# **WANG CARTRIDGE MODULE DISK DRIVE CDC MODEL 9448 CMD (PHOENIX DRIVE)**

## **ADDENDUM TWO**

2280 "PHOENIX" ADDENDUM (TWO) SUPPLEMENT TO FIELD-LEVEL  
MAINTENANCE MANUAL 03-0800

FIGURE 4-2A ELECTRONICS MODULE CONTROL/MUX PWA

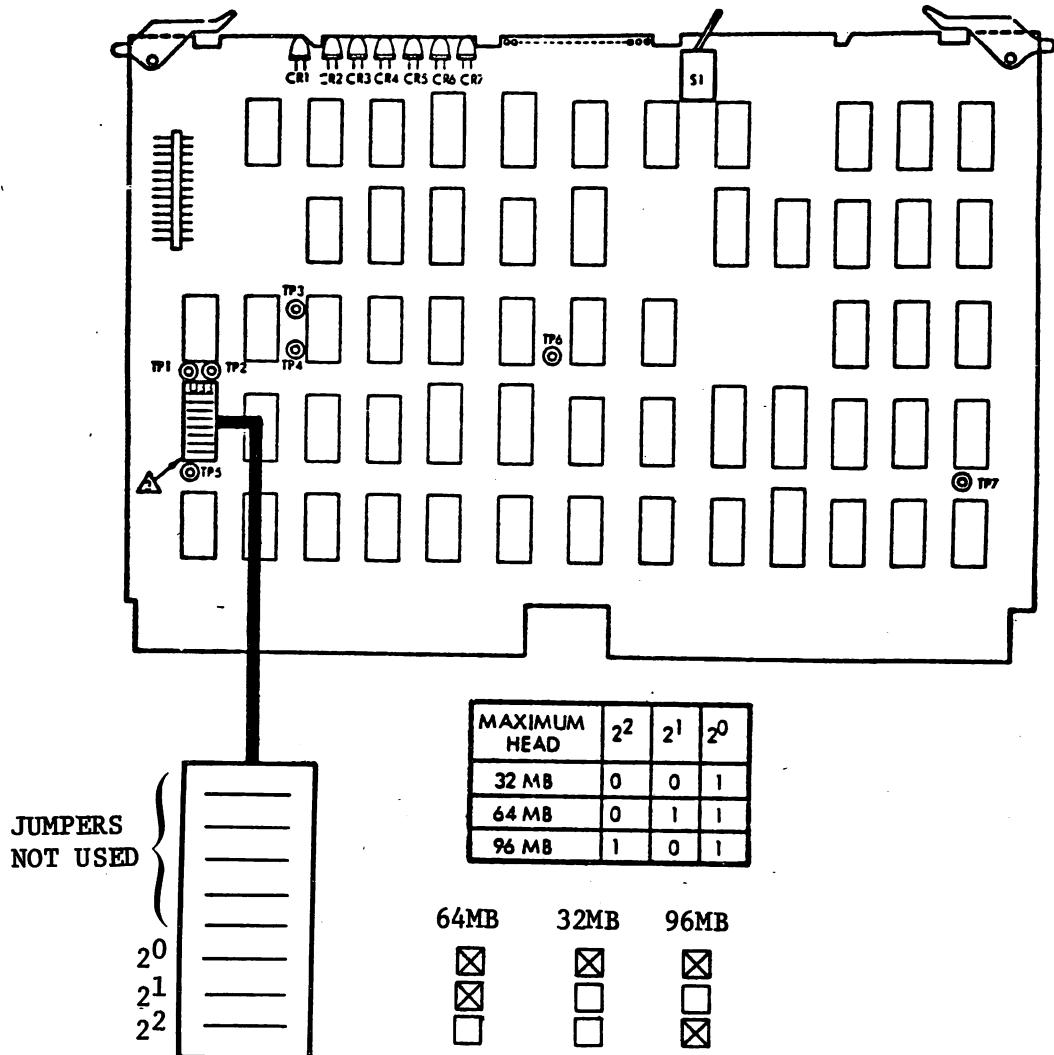
1. FIGURE 4-2

Supplement Figure 4-2 on page 4-6 with enclosed Figure 4-2A.

(Figure 4-2A illustrates the jumper cuts required on U33 for data storage as shown on the enclosed chart rather than the earlier use of installing jumpers).

NOTES: 1. ☒ = CUT JUMPER (LOGIC 1 IN TABLE)

FIGURE 4-5A MICROPROCESSOR PCB - (SERVO-COURSE)

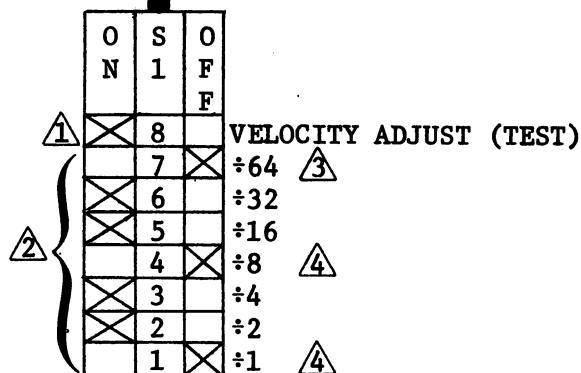
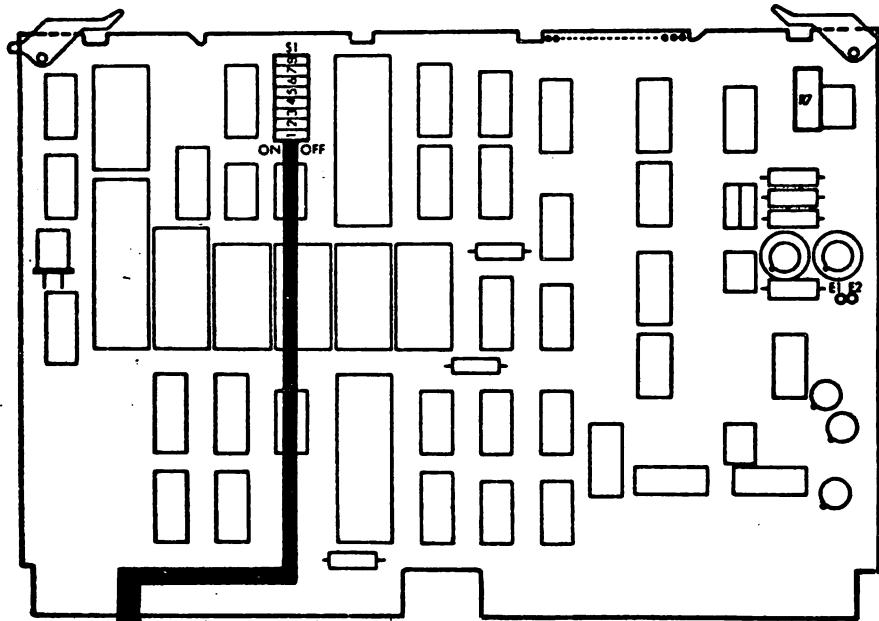
2. FIGURE 4-5

Supplement Figure 4-5 on page 4-12 with enclosed Figure 4-5A.

(Figure 4-5A illustrates the settings of the S1 sector selection switches on the Coarse Servo Board).

NOTES: ① S1 MUST BE ON (DOWN) FOR NORMAL I/O OPERATION.

② NO. OF SECTORS ARE SET BY SELECTING COMPLEMENT  
I.E., FOR 64 SECTORS SET S1-7 OFF AND S1-1 THRU S1-6 ON.

③ FOR 2200 64 SECTOR

④ FOR 2200VS 9 SECTORS

FIGURE A-10

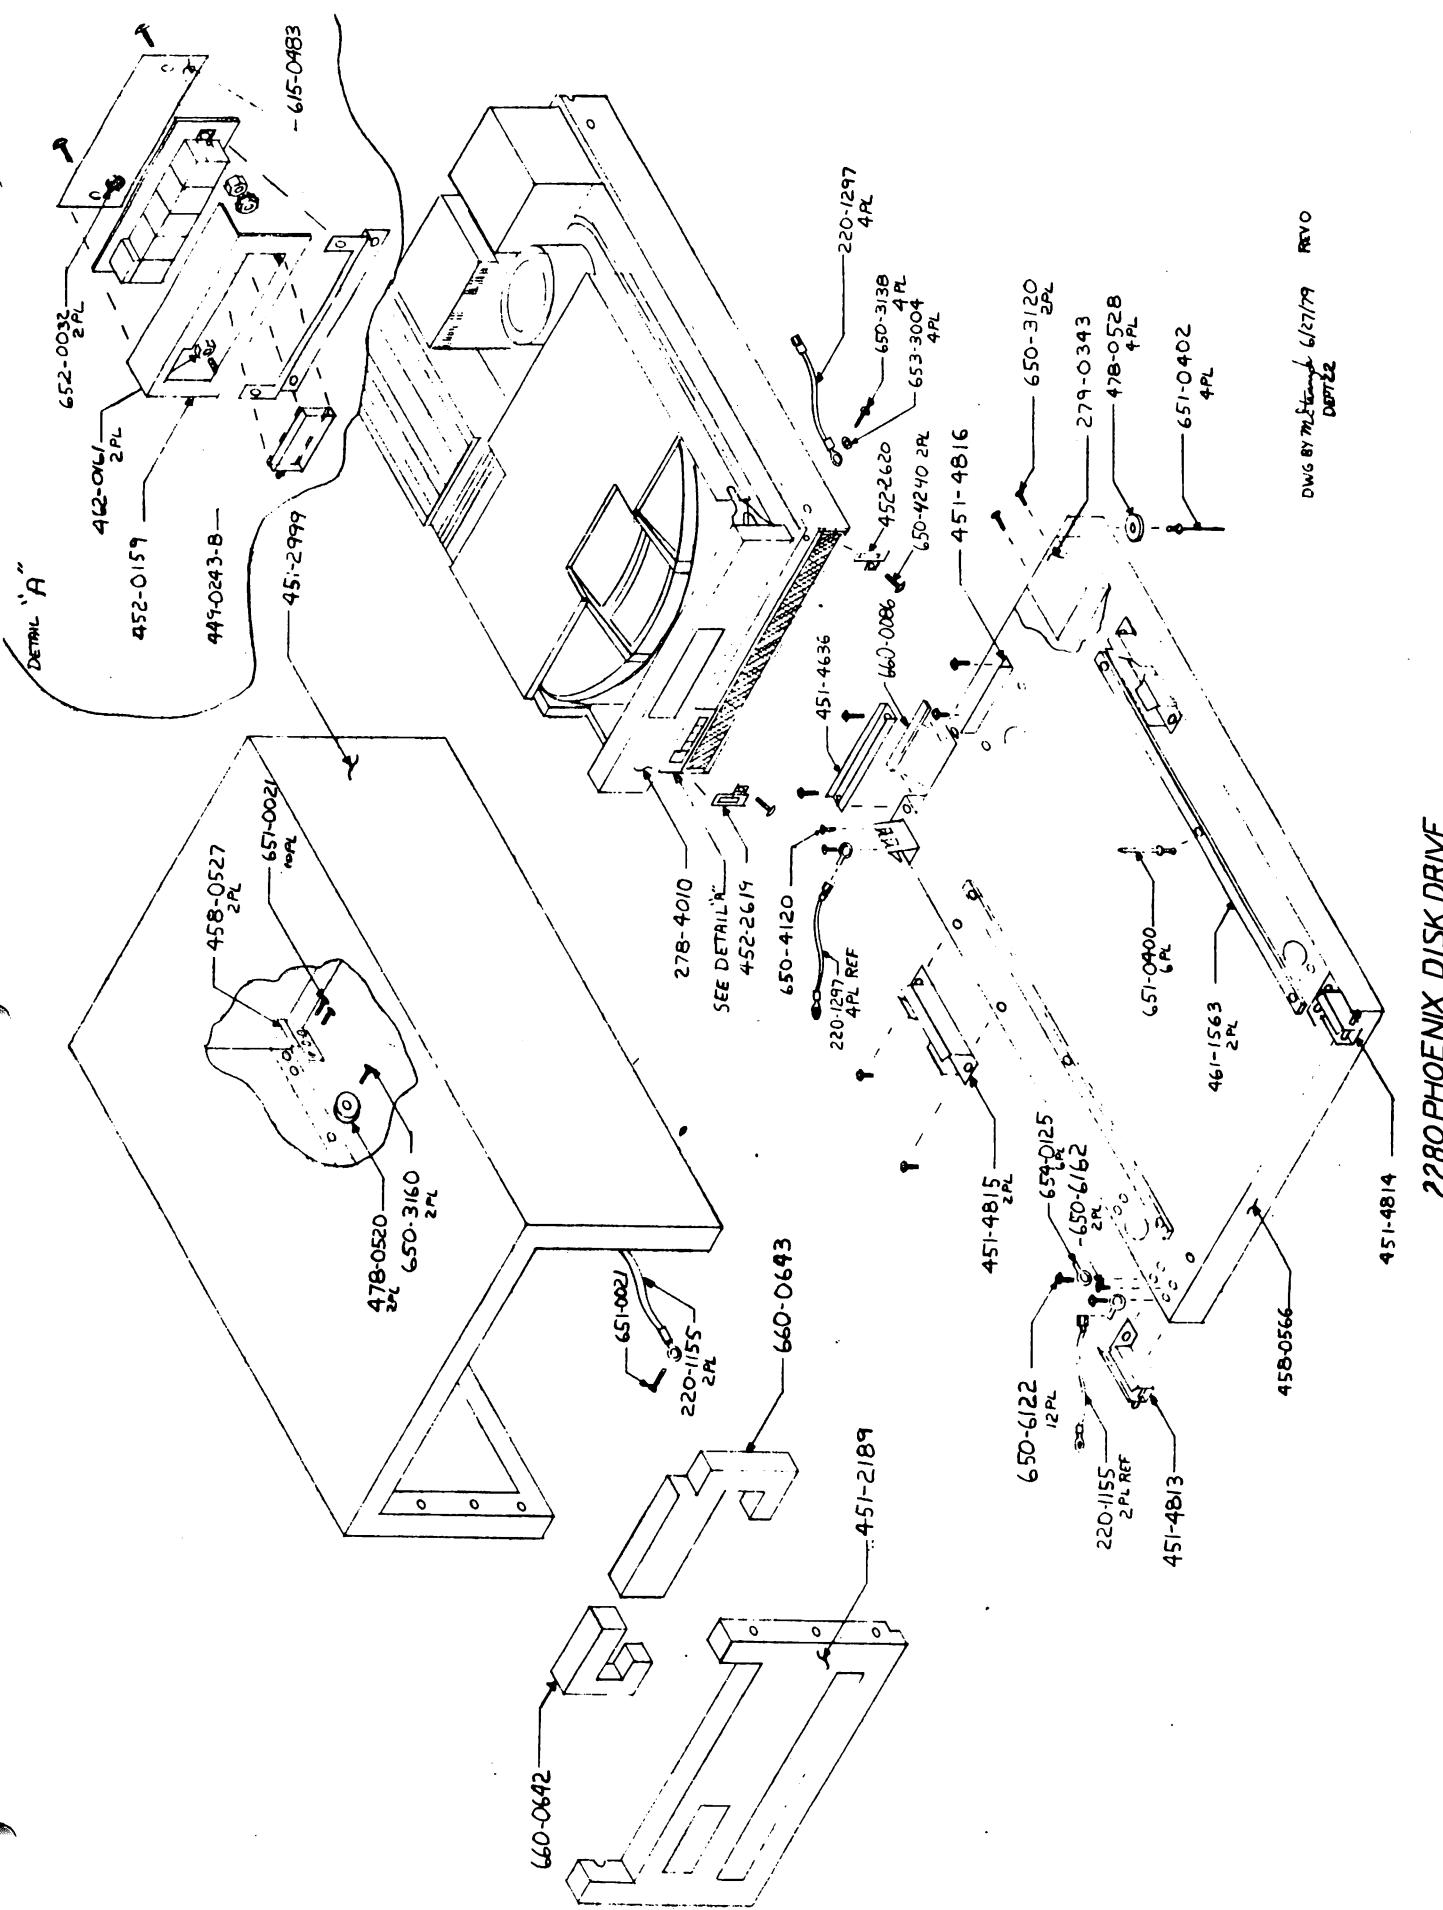
The Exploded view of the "PHOENIX" Disk Drive is added to Appendix A for an additional source of Part Numbers to assist in replacing defective or broken parts. Insert this illustration into Appendix A as Figure A-10. See list of parts below:
